# Access Compliance Report

## Public Rights-of-Way

Intersection ID: 49803	Main Street: ATKINS_RIDGE_DR	Cross Street: MATARESE_CT	Location: S
ADA ID: 0371D9F8167D	Ramp Type: PerpDiag	Initial Pass/Fail: Fail	Overall Compliance: No
Codes/Mitigation Info/Possible Solution		Field Measurements/Component Compliance

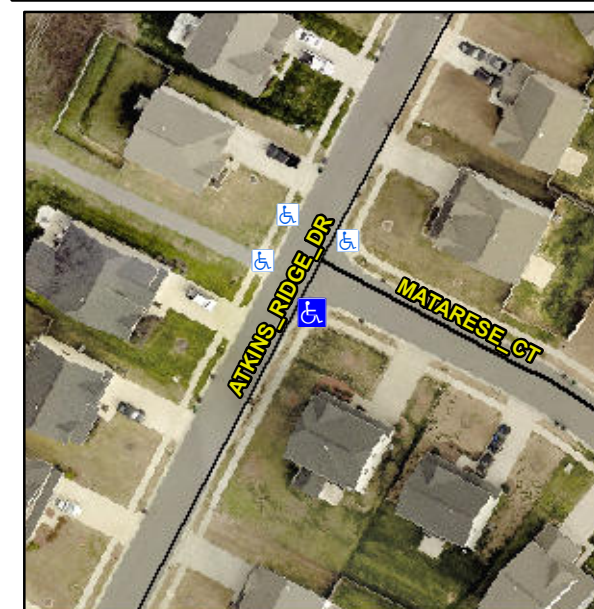
**Not Found, R304.5.1, R304.5.3**

Compliance	Description	Data	Compliance	Description	Data
N/A	Ramp Length (in)	49.0	Yes	Ramp Slope (%)	6.2
No	Ramp Width (in)	47.0	No	Ramp XSlope (%)	7.3
N/A	Flare Type LT	N/A	N/A	Flare Type RT	N/A
N/A	Flare Slope LT (%)	N/A	N/A	Flare Slope RT (%)	N/A
N/A	Flare Traversable LT?	N/A	N/A	Flare Traversable RT?	N/A
N/A	Landing Length (in)	N/A	N/A	DWS Provided?	N/A
N/A	Landing Width (in)	N/A	N/A	DWS Contrast?	N/A
N/A	Landing Slope (%)	N/A	N/A	DWS Length (in)	N/A
N/A	Landing X Slope (%)	N/A	N/A	DWS Full Width?	N/A
N/A	Landing Curb? (Y/N)	N/A	N/A	DWS Offset (in)	N/A
N/A	Shared Landing?	N/A			
N/A	Gutter Ponding?	N/A	N/A	Gutter Slope (%)	N/A
N/A	Gutter Lip Ht (in)	N/A	N/A	Gutter X Slope (%)	N/A
N/A	Painted X Walk1?	No	N/A	Painted X Walk2?	No
	X Walk 1 Direction	To NE		X Walk 2 Direction	To NW
N/A	X Walk 1 Width (in)	N/A	N/A	X Walk 2 Width (in)	N/A
	X Walk 1 Slope (%)	7.1		X Walk 2 Slope (%)	0.5
	X Walk 1 X Slope (%)	3.9		X Walk 2 X Slope (%)	6.8

**Remove & Replace Curb Ramp With Two New Directional Ramps or Equivalent.**
